Technical Service Bulletin

MODEL(S) AFFECTED: Speed Scrub Rider 650MM Disk Only

SUBJECT: Potential interference between Brush spring and scrub deck causing a ticking noise. This affects Brushes and Pad Driver listed below that were released in the field before May 2016 or shortly after.

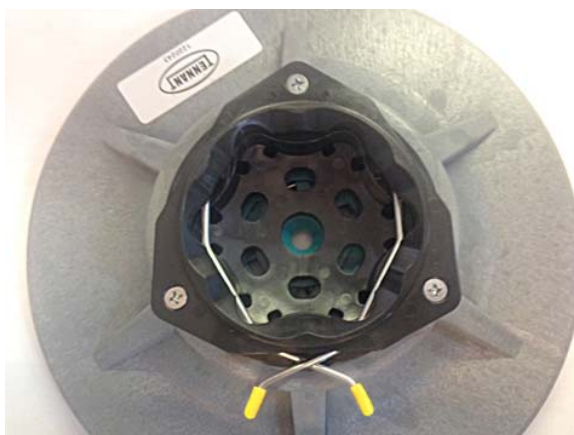
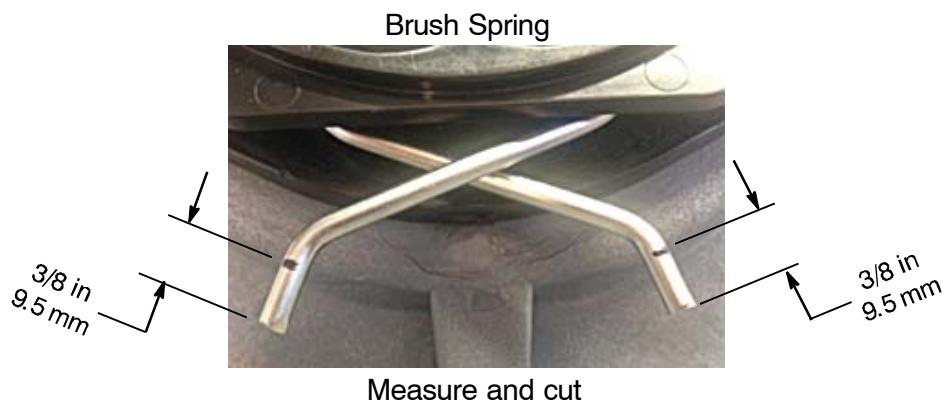
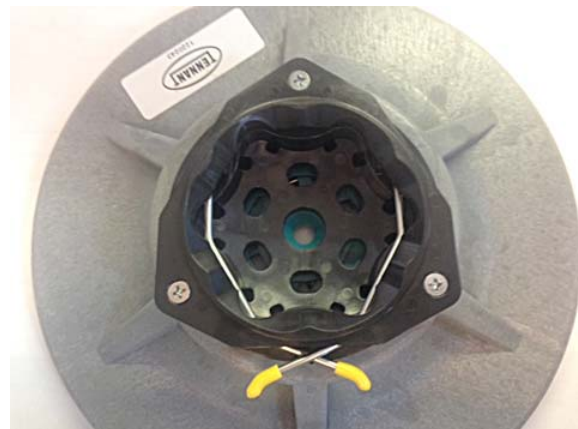
PURPOSE: If this condition exists, the spring on the brush/pad driver will need to be shortened as described below.

1. Remove yellow vinyl caps from brush spring ends.
2. Measure and mark $\frac{3}{8}$ in / 9.5 mm from both spring ends.
3. Using a cutting tool, cut spring ends where marked. De-bur the cut end as needed.
4. Replace yellow vinyl caps.
